Southwark, Lambeth and Wandsworth

Cycling and Traffic Management Partnership – 30 Sept 2015 (7am to 9am ride)

Minutes

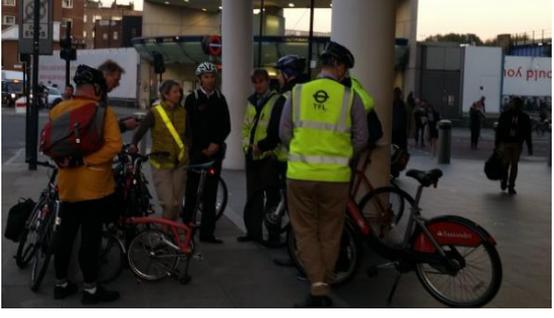
Zone and location Item	Comments	Actions/Responses
	<p>Shell bridge due to removed from next week, but no advance warning installed by Lambeth to pedal or vehicle mode</p>	<p>Signage issue escalated to developer same day now in place</p>
<p>Zone 3. Vauxhall Tavern</p>		
	<p>Sand slip hazard not cleared (close to contractor storage materials)</p>	<p>AL to action</p>
 	<p>Northbound, major new development will remove the bus/pedal mode segregated "gate" to accommodated site deliveries. TBC</p> <p>Is there potential to provide a pedal route for Northbound pedal mode to the 2-way cycle track and connect with Vauxhall CSH?</p>	<p>MB to review original scheme approval</p>

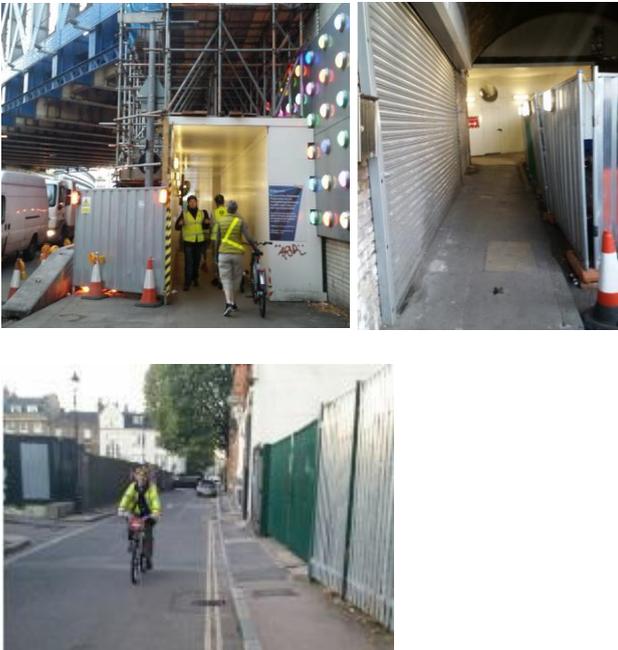
Zone and location Item	Comments	Actions/Responses
<p>Zone 4. Kennington Park Rd</p> 	<p>What was the reason for cones placed ~1m away from barriers (towards Brixton Road)?</p>	<p>PW to review</p>
	<p>Will the new cycle track at Oval (Brixton Road) be smooth and without surface defects?</p> <p>Existing “uneven” track surfaces at Oval unresolved.</p>	<p>PW escalate response from contractors.</p>
	<p>Brixton Road at Oval Southbound. Heras fencing support blocks missing warning cones. Potentially dangerous to cycle mode at night when blocks stick out.</p> <p>Uneven fencing line without cones, creating pinch point.</p>	<p>PW escalate to contractors.</p>
<p>Zone 4. Brixton Road</p>

Zone and location Item	Comments	Actions/Responses
<p>1/ </p> <p>2/ </p>	<p>1/ Guidelines suggest an advisory arrow is needed at the start and end of TM road narrowing.</p> <p>As seen, the very large arrow and cones causing severe pinch point to pedal mode.</p> <p>2/ Area has significant pedestrian desire line to bus stops and shops, but there are no barrier breaks for pedestrian safety.</p> <p>Could cone mounted type TM signs be used in comprised sites?</p> 	<p>On the day, signage removed.</p> <p>PW to review TM regarding pedestrian flows as being seen.</p>
	<p>Advance warning signs (before Prima Road) obscured by buses at multiple bus stops and bus standing (often three buses in a row). "Narrow lanes" and "no left turn" signs obscured.</p>	<p>PW to review TM</p>
	<p>Northbound, (at triangle on Brixton Road) poorly sited TM signage on footway.</p> <p>Insufficient width/layout to pedestrians and wheelchair, pushchair/family users.</p>	<p>PW to review</p>
